TITLE: **7.5" GATE CONVERSION**

SUBTITLE: INSTRUCTION MODIFICATIONS

NUMBER: **GATE 03**

Conversion of Transland 7.5" Electric gate to 7.5" Reabe Smart Gate

Figure 1

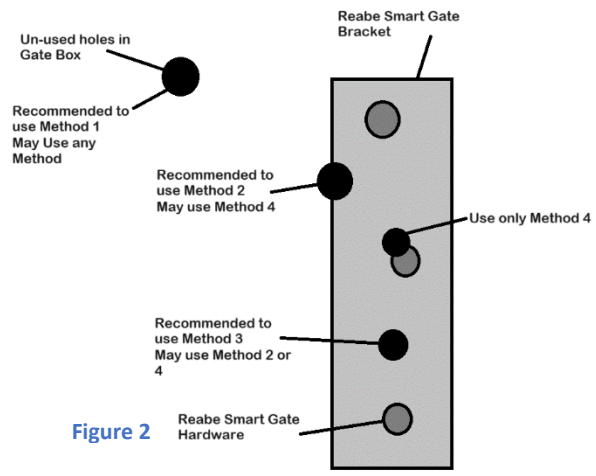
In Step A.b.4 you will also need to remove the Gate Quick Attach Guide and Transland Motor Support Bracket highlighted in Figure 1.
